Intervale Preserve Request for Proposals (RFP)

Clarifying Comments

Figure 1. Labeled Warbler Trail and Water Access Trail Map

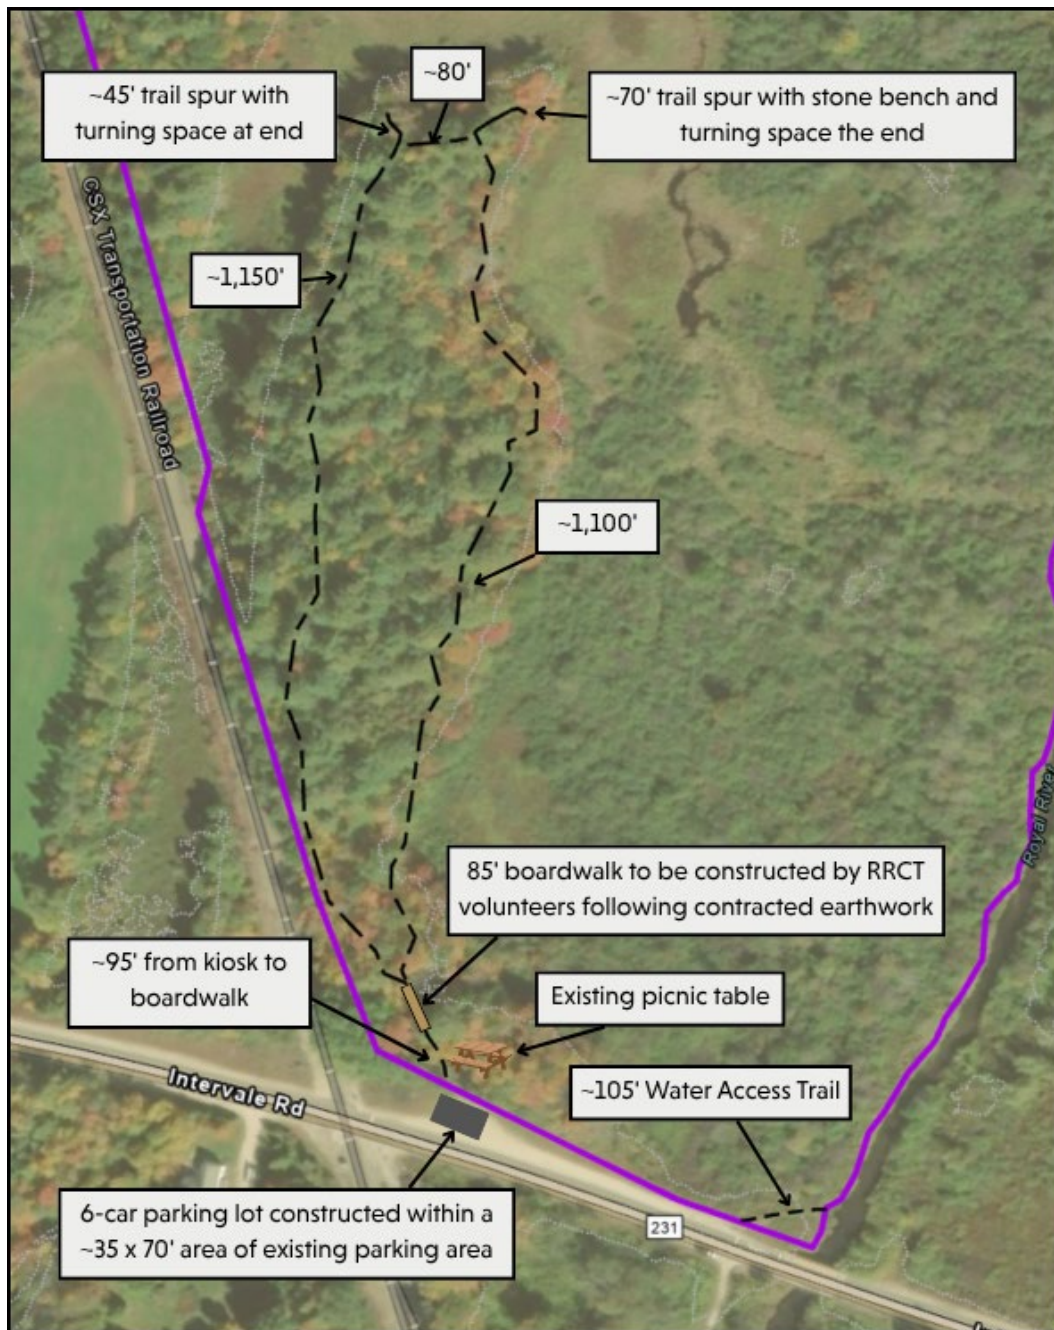
- The trail will be closed to the public during construction.
- The 85-foot stretch of bog bridging currently present on the trail will be removed by Royal River Conservation trust (RRCT) staff and volunteers prior to contractor construction of trail earthwork. Contractors can drive a mini excavator or other equipment needed along the bare earth where the bog bridging was to reach the rest of the trail. There are no other suitable access points to bring in equipment or gravel.

- The 5-foot-wide earthwork will begin at the kiosk. The trail should blend seamlessly with the 6-space gravel parking lot. The trail will continue for ~95 feet before transitioning to the ~85 boardwalk.
- A circular or T-shaped turning space should be added to the end of the two trail spurs.
